UNITED STATES PATENT AND TRADEMARK OFFICE

APPLICATION NO.	FILING DATE	FIRST NAMED INVENTOR	ATTORNEY DOCKET NO.	CONFIRMATION NO.
09/928,725	08/13/2001	Randy E. Dewhirst	D-2550A/WOD	7156

Office Action Summary

DETAILED ACTION

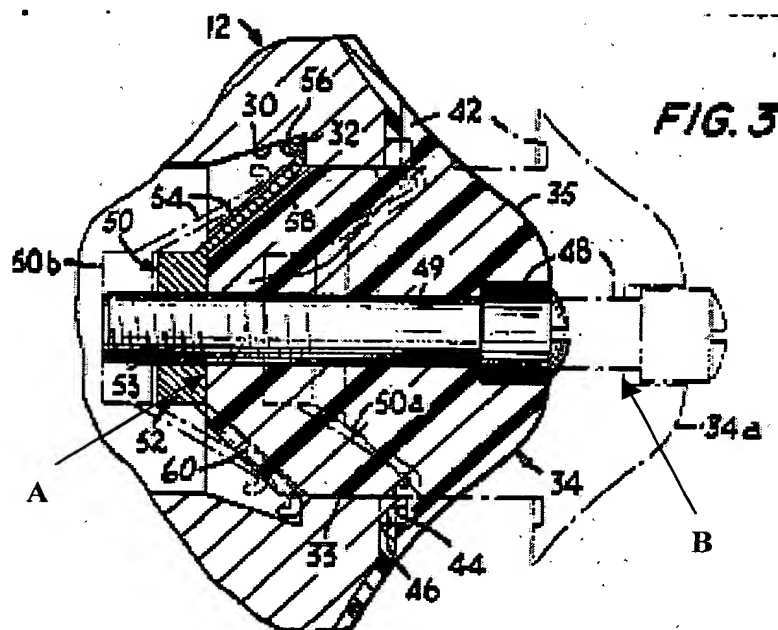
Claims 34-53 are rejected under 35 U.S.C. 102(b) as being anticipated by Zoehfeld (US 3,387,768). With regard to claim 34, Zoehfeld discloses a spacer body **34** comprising a front face **35** having an aerodynamic contour (column 2 lines 41-44) symmetrically arranged about an axis; a rear face axially spaced from the front face (see generally figures 1 and 3); a recessed [spring bearing] surface **58** in the rear face; a spring spacing abutment **A** projecting in an axial direction from the bearing surface **58** (see edited figure 3 below); and a central bore **49** (see figure 3; column 2 line 57).

With regard to claim 37, Zoehfeld shows the front face 35 of the spacer body 34 including a recess B (see edited figure 3 above).

With regard to claim 38, Zoehfeld shows an abutment A sized to control the axial load on an expensor 54 when the expensor 54 is located radially outward of the abutment A (see edited figure 3 above).

With regard to claim 41, Zoehfeld shows the abutment **A** including a second shoulder located proximal the axis (intersection of abutment **A** and center bore surface **49**) (see edited figure 3 above).

With regard to claim 43, Zoehfeld further discloses the contoured spacer body **34** including a center portion having a recess **58** arranged in the rear surface about the spring spacing abutment **A** (see edited figure 3 above).

With regard to claim 45, Zoehfeld shows the front surface **35** including a recess **B** and a forward facing shoulder in the recess **B** (see edited figure 3 above).

With regard to claim 46, Zoehfeld further shows the recess **B** sized to ensure that the front [surface] **35** is seated flush across the central bore **49** in order to make a substantially continuous surface (see edited figure 3 above).

With regard to claim 49, Zoehfeld further shows the body **34** having an aerodynamic portion **35** extending slightly around the spring spacing abutment **A** (see edited figure 3).

With regard to claim 50, Zoehfeld also shows the rear surface providing an outer shoulder (intersection of abutment **A** and bearing recess **58**) spaced radially outwardly and an inner shoulder (intersection of abutment **A** and center bore surface **49**) surface spaced radially inwardly (see edited figure 3 above).

With regard to claim 52, Zoehfeld further shows the front face **35** including a recess **B** (see edited figure 3 above).
